AMENDING POADP No. 395
 Decrease the acreage from 11.75 acres to 6.50 acres.
 Decrease the number of lots from 35 to 33.

THE HEIGHTS, UNITS 1, 2 & 3
 PLANNED UNIT DEVELOPMENT
 FINAL PLAN

MDP # 395-A

Proposed MDP and PUD #04-017

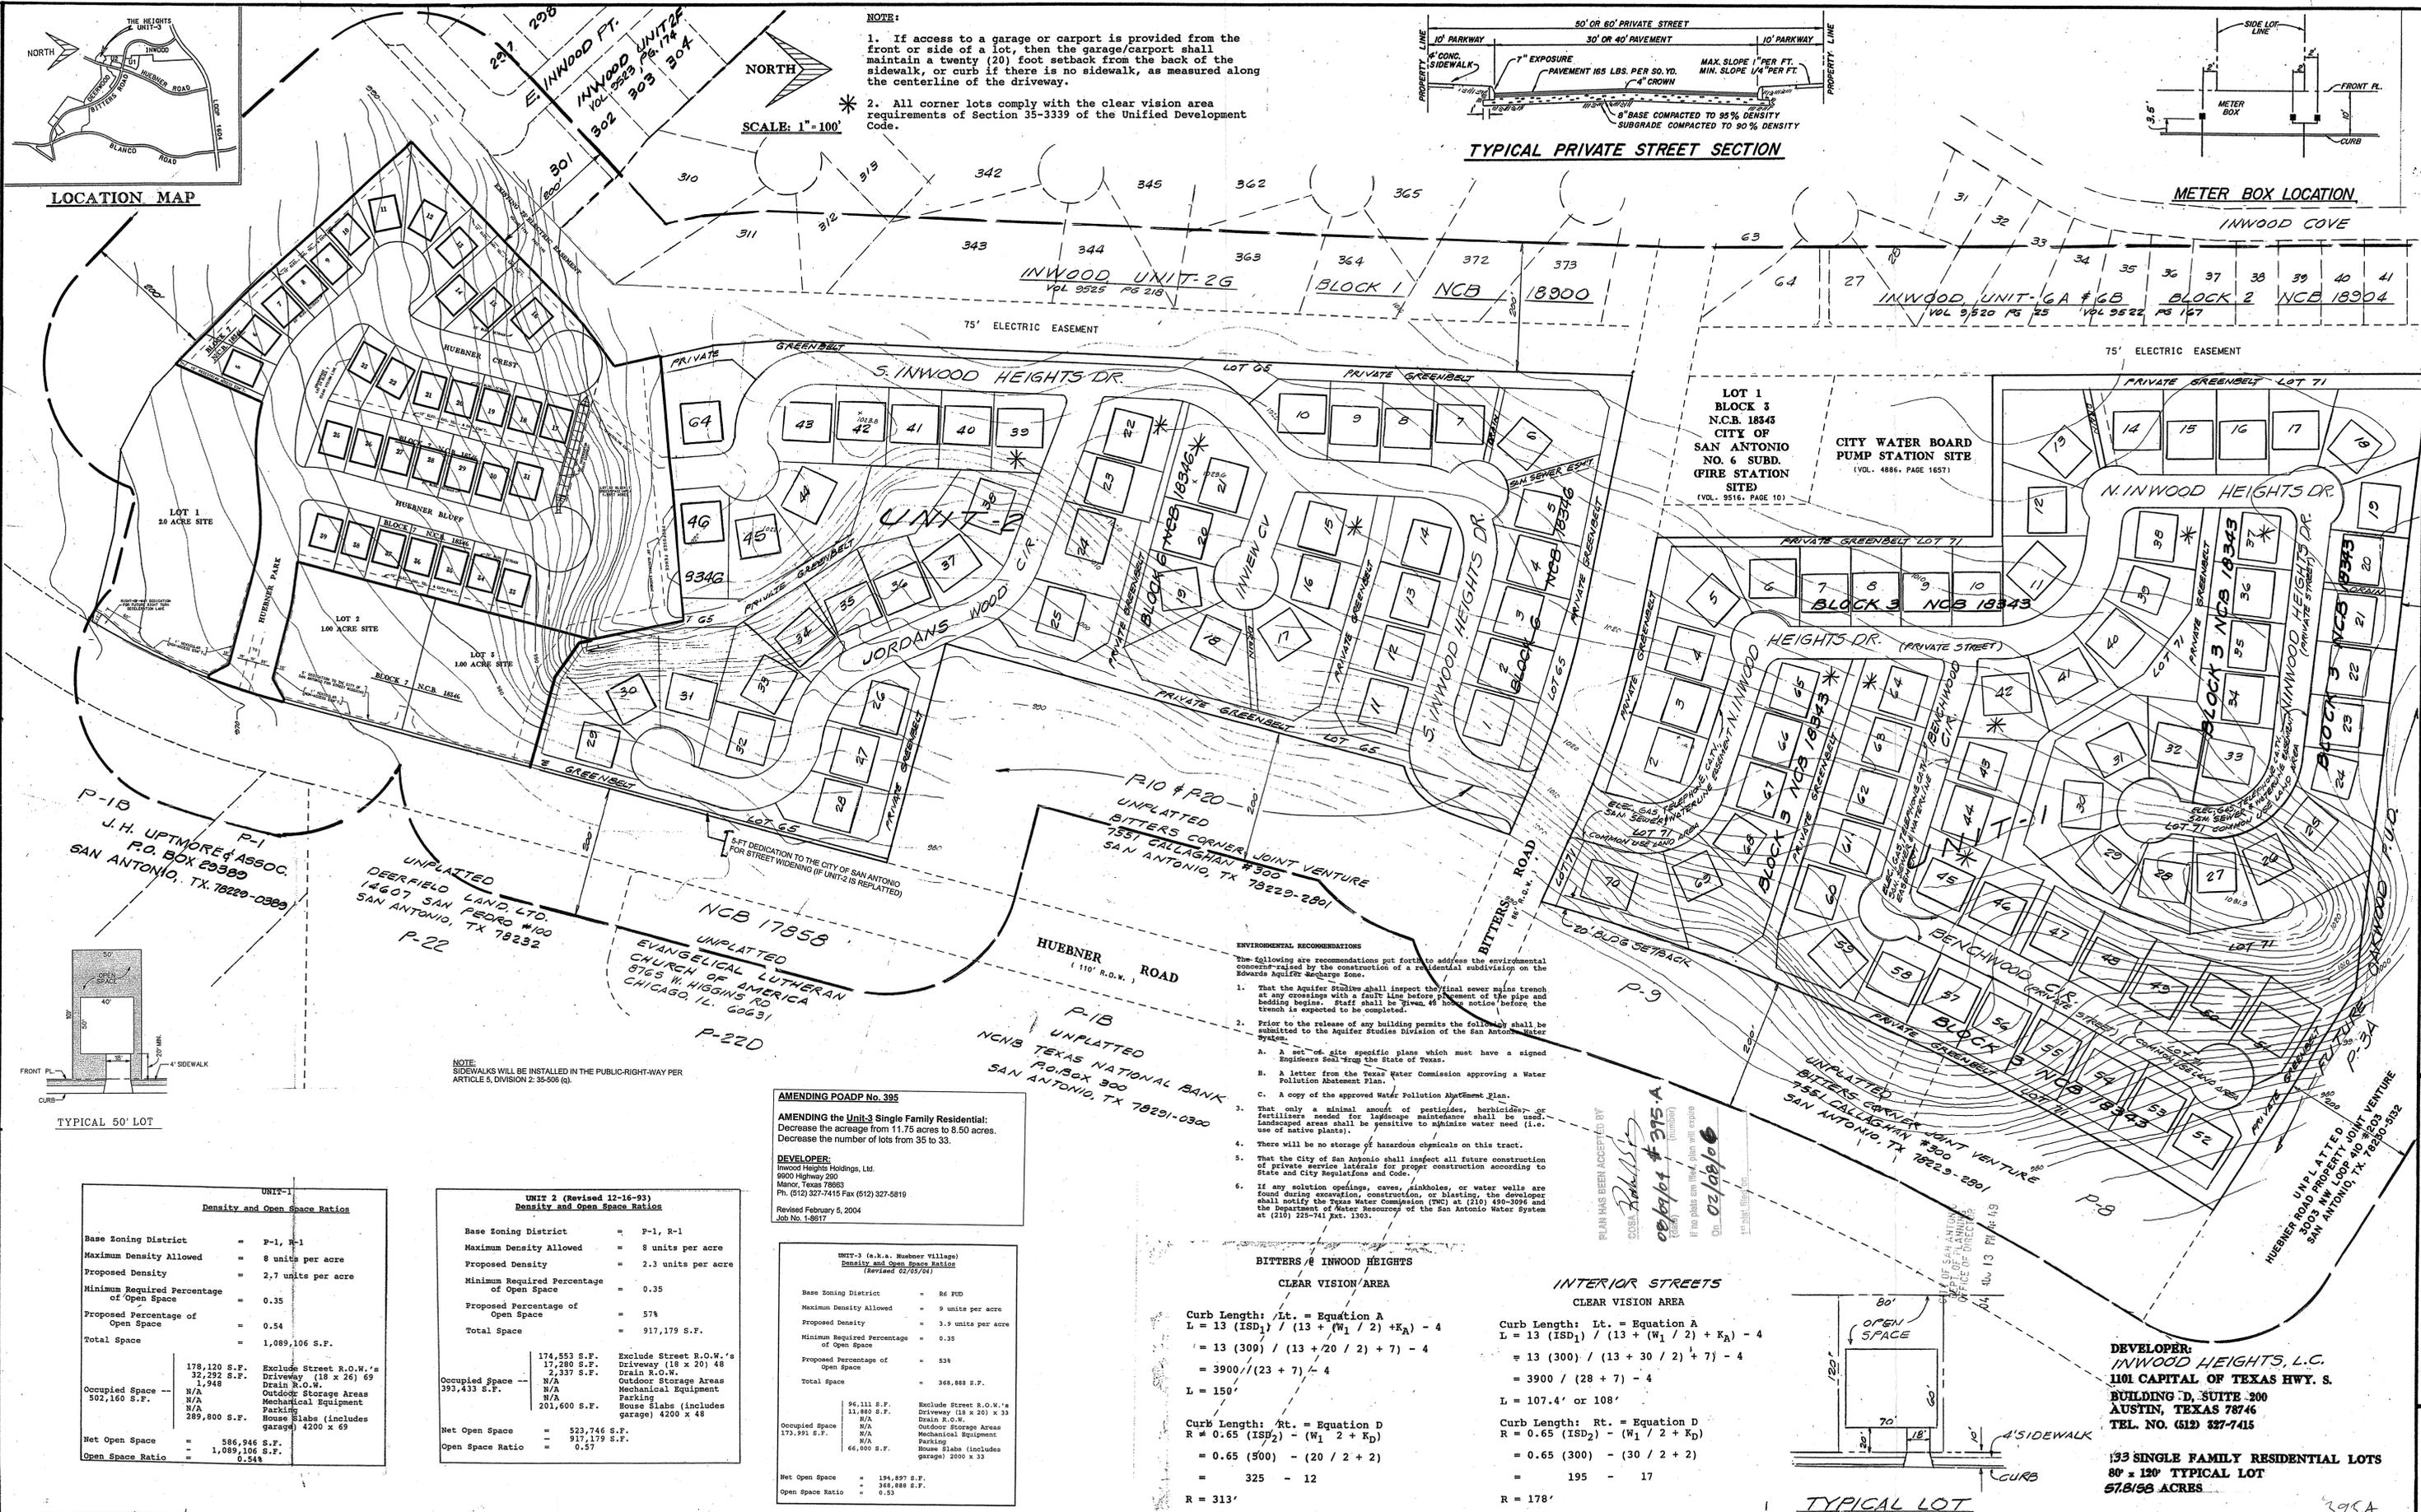
- Zoning approves with the condition that zoning references on Lots 1,2, and 3, Block 7, NCAB 18346 on the south end of the plan ("Zoned C-2") be removed. This is not accurate. That property is not zoned C-2.
- This project is subject to the Streetscape standards. For information about these requirements you can contact Tree Preservation at (210) 207-0278.

- Development Services/ Planning – Master Development Plan (MDP) and Major Thoroughfare Plan (MTP) review cites the following:
 - 1) Proposed plans identify a dead end street between lots 64 and 46 that do not provide any plans for future connectivity with relationship to Unit 3.

- 2) And or Unit 3 of the above mentioned PUD plan does not provide connection to Unit 2 provisions of an extended street.

2001 UDC – Chapter 35, Article 5, Division 2, Section 35-506(e)(5) Dead-end Streets.

“Dead-end streets shall be prohibited except as short stubs to permit future expansion. A “short stub” is defined as being the average depth of the adjacent lot within the subdivision.”

2001 UDC – Chapter 35, Article 5, Division 2, Section 35-506(e)(2)

“Where necessary to the neighborhood pattern, existing Streets in adjoining areas shall be continued and shall be at least as wide as such existing Streets and in alignment therewith.”
